Valley of the Moon Park

Master Plan 2015

Valley of the Moon Park Master Site Plan

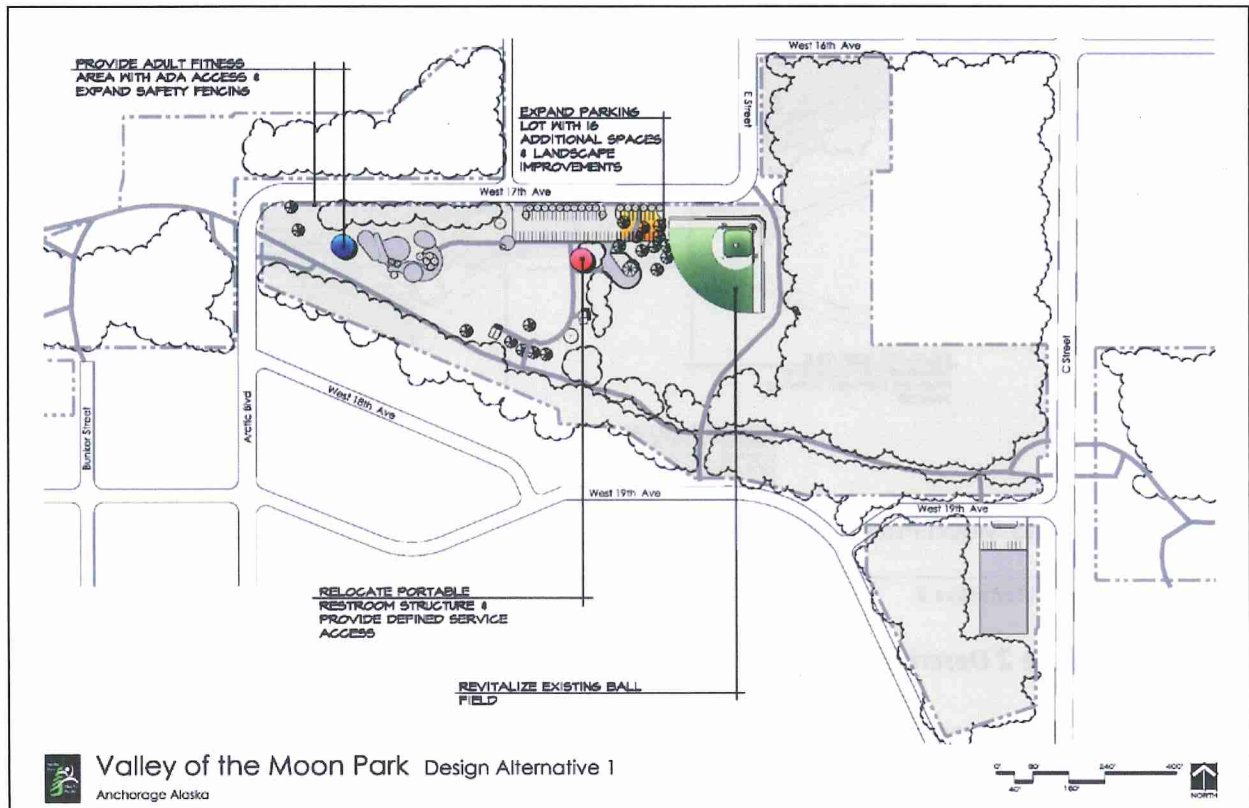
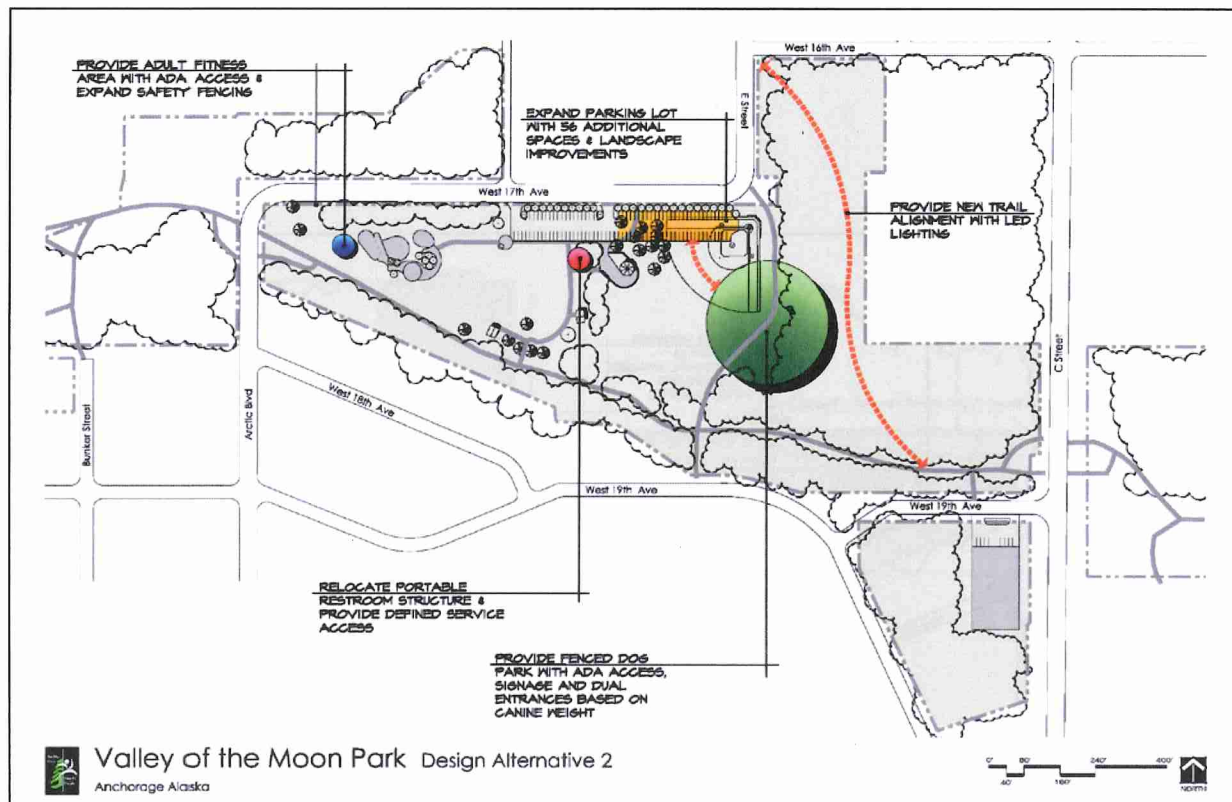
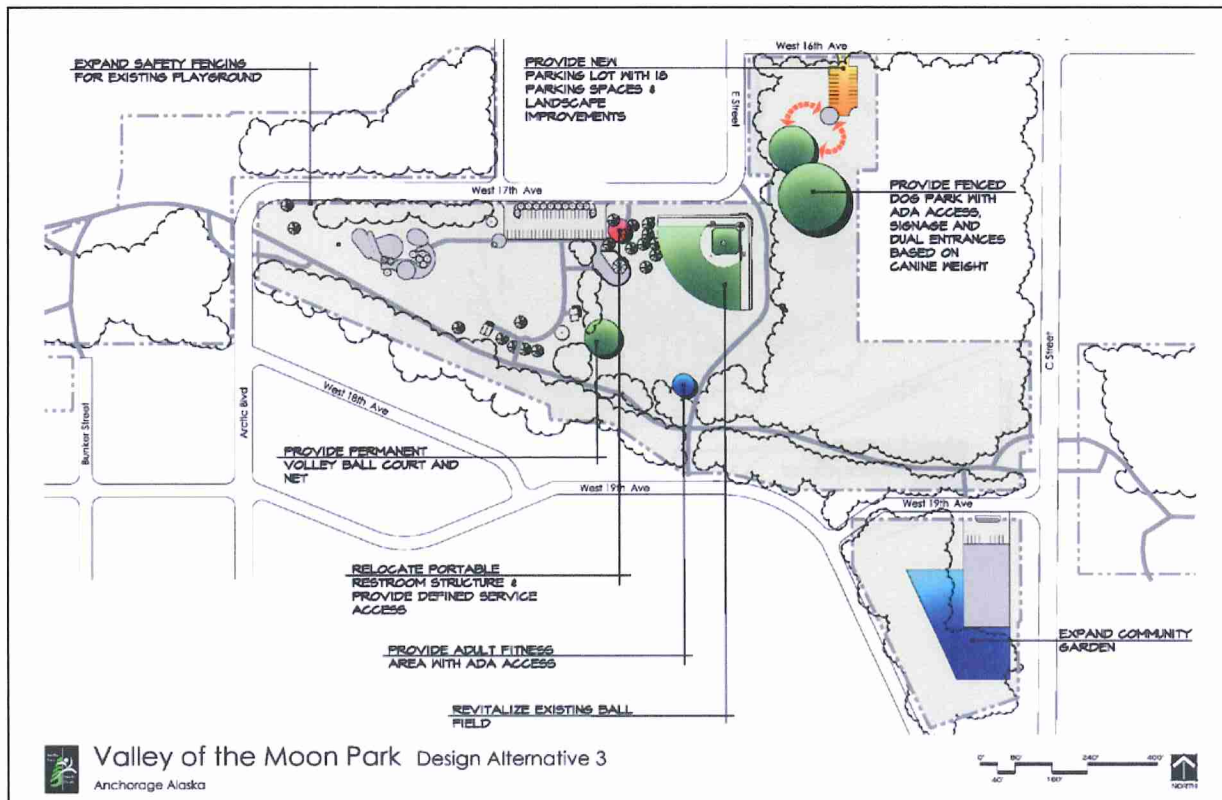
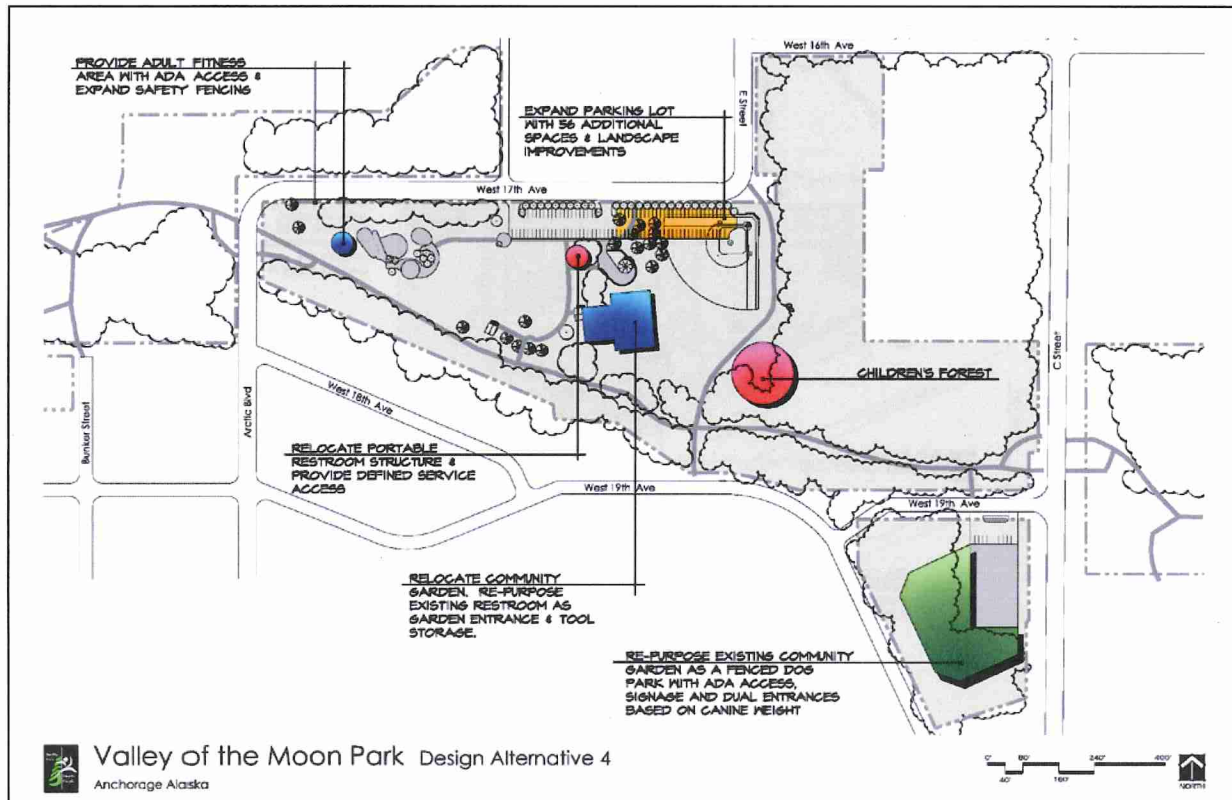
- Does not like community garden in the middle of the park because the open space is often used for picnics and play (concept #4); if community garden is moved it would be preferable to move it to the current location of the ball field to preserve the open space
- Likes adult fitness area by the playground
- Likes driving by community gardens on C Street and watching it grow through the season
- Likes concept #2: dog park in woods, re-routed bike path through the woods, and extra parking
- Remove the dugouts and replace with benches to prevent undesirable behavior taking place in the dugouts and to eliminate hiding places and litter

- Sees an opportunity for education at the community garden
- Prefers the adult fitness station in a more central location, cites that it is may be awkward for single males to work out near a playground (P&R response: the design would include a small plaza to provide a comfortable separation but still maintain a line of sight so that parents could watch their children on the playground)

- Add special parking for food truck vendors
- Promote more bike and pedestrian access as well as more visible public transit
- Asked about the absence of a pump track from the design alternatives (P&R response: the Parks department is currently working on pump tracks and other bike facilities in other parks and recommends that this new use is not tested at Valley of the Moon Park at this time)

- Clearly feels that concept #3 is the best
- Would like to add the Children's Forest from concept #4 to concept #3 and include archway entrances in the design
- Prefers adult fitness station near the playground

Adult Fitness Equipment: The advisory group supports the addition of an adult fitness station located west of the playground. This location would allow adults to work out and supervise their children on the playground. A plaza is recommended to provide a comfortable separation but still maintain a line of sight so that parents are able to watch their children on the playground. An access trail connecting directly to the Chester Creek Trail should also be considered in the design.

Parking Lot: The group agrees that additional parking at the Valley of the Moon Park will help alleviate overflow parking on 17th Ave. However, the location and amount of parking to be added has yet to be resolved. The four proposed design alternatives include between 16 and 56 additional spaces. Conversation between the group and Parks and Recreation staff suggest that somewhere in the middle would be most appropriate. The group agrees that an expansion of the parking lot east of its current location is, at present, the most logical location but expressed some interest in exploring the feasibility of a small parking lot off of 16th Ave.

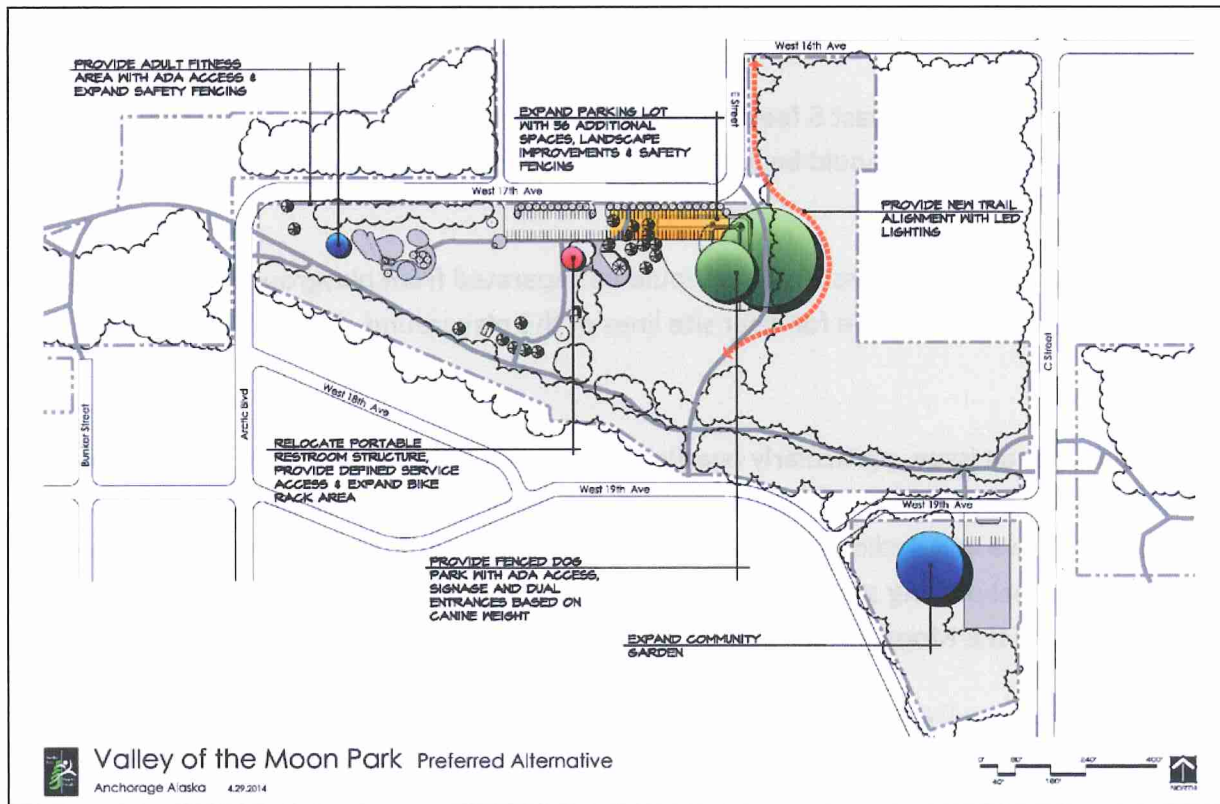
- Dog Park: fix the fence, don't move it; the current surface/field turf is good; add a bench for older folks to rest
- Adult Fitness: like the adult fitness area
- More Parking: supports more parking, on-street parking is dangerous and additional parking would be better even if it moves into the fenced dog area
- Priorities: fix the dog park fence, move port-a-potties

- General: feels that the park is a great park as is and that there is no need to change it that much; the playground and picnic shelters are very active and the park as a whole functions very well; money should be spent on making things better rather than changing and relocating amenities (i.e. bike path)
- Adult Fitness: supports the addition of an adult fitness area
- Fencing: supports expanding the fencing along 17th Ave
- Community Garden: supports expanding the community garden
- Dog Park: the size of what is currently used as an off-leash area is plenty
- Bike Trail: the trail is fine in its current location and does not come too close to the off-leash area; there is no need to re-locate the trail
- Priorities: port-a-potties first, ameliorate the northern end of the dog park for parking space, expand fencing along 17th Ave

- Ball field: save the ball field; possibly remove the outfield fence, keep the sideline fences, remove the dugout to eliminate the unwanted visitor problem and debris problem
- Dog Park: locate the dog park in the northeast area of the park and save the expense of moving the trail
- Forest: the forest is currently a barrier and doesn't feel as if it is part of the park; open up forest, thin trees and bring into park; consider adding a "park ends here" sign to delineate the park boundary
- Bike Trail: does not support the expense of moving the trail
- Bike Lane: not sure if willing to give up on-street parking for a bike lane
- Priorities: expand fence along 17th Ave, move port-a-potties

- General: I like most of what is presented in the Preferred Alternative
- Parking Lot: supports additional parking; add more parking as this town is mostly automobile commuters
- Dog Park: would like the dog park to stay in the ball field area and move a little to the south; add trash cans and a double entry
- Community Garden: supports expanding the community garden and thinks that it is a great thing
- Priorities: dog park fence, port-a-potties, dog amenities (if we are planning for parking, we might as well move that now - depending on what the study says)

- Expand the fencing along 17th Ave to improve safety near the playground
- Add adult fitness area to the west of the playground with a connection to the trail system
- Expand the C Street Community Garden to the west to accommodate demand for garden plots and those on the waitlist
- Move the restroom screen and port-a-potties to a serviceable location
- Formally designate a dog park in the present location of the ball field with upgraded fencing and entrances

Parks and Recreation will amend the Preferred Alternative based on feedback from this meeting. This summer, Parks and Recreation will study parking issues at Valley of the Moon Park. In the fall, the Department will make recommendations addressing parking and will present the final site plan for approval.

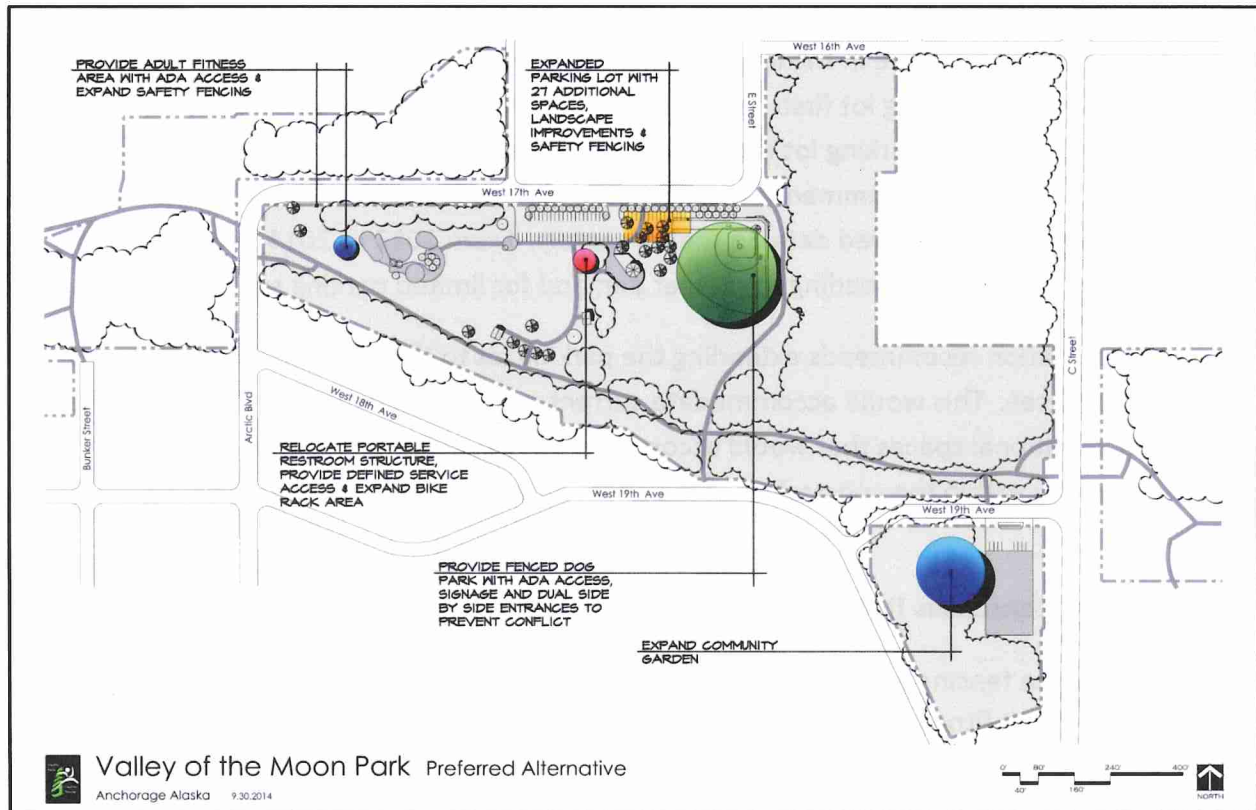
- Expand the fencing along 17th Ave to improve safety
- Add an adult fitness area to the west of the playground, include a paved connection to the trail system
- Expand the C Street community gardens
 - *AG feedback: expansion up to twice the size could be appropriate, the dimensions and location should be determined with feedback from neighbors and garden users*
- Move the restroom screen and port-a-potties to a serviceable location
- Formalize the dog in the location of the ball field, upgrade fencing and entrances
 - *AG feedback:*
 - *AB: locate trash cans near park entrances, address issues of overflowing trash cans*
 - *MB: the dog park should not extend any further south into the open space than its present location*
 - *PB: remove the dugouts immediately (reason: people sleeping in dugouts, dumping trash, and defecating in them), turn on water for dogs to drink*

- *MJ: look into the wooden home plate – is there any historical significance?*
- Maintain current alignment of north-south bike/pedestrian trail
 - *AG feedback:*
 - *MB: are there any plans to continue the bike trail to the east of the bollards up to 16th Ave?*
- Expand parking lot to the east and add 27 spaces

Parks and Recreation recommends extending the parking lot to the east with an additional 27 new parking spaces. This would accommodate current overflow parking as well as meet the demand for additional spaces that would accompany the development of a new dog park. This design also works within the constraints of the site with minimal disruption to existing activities.
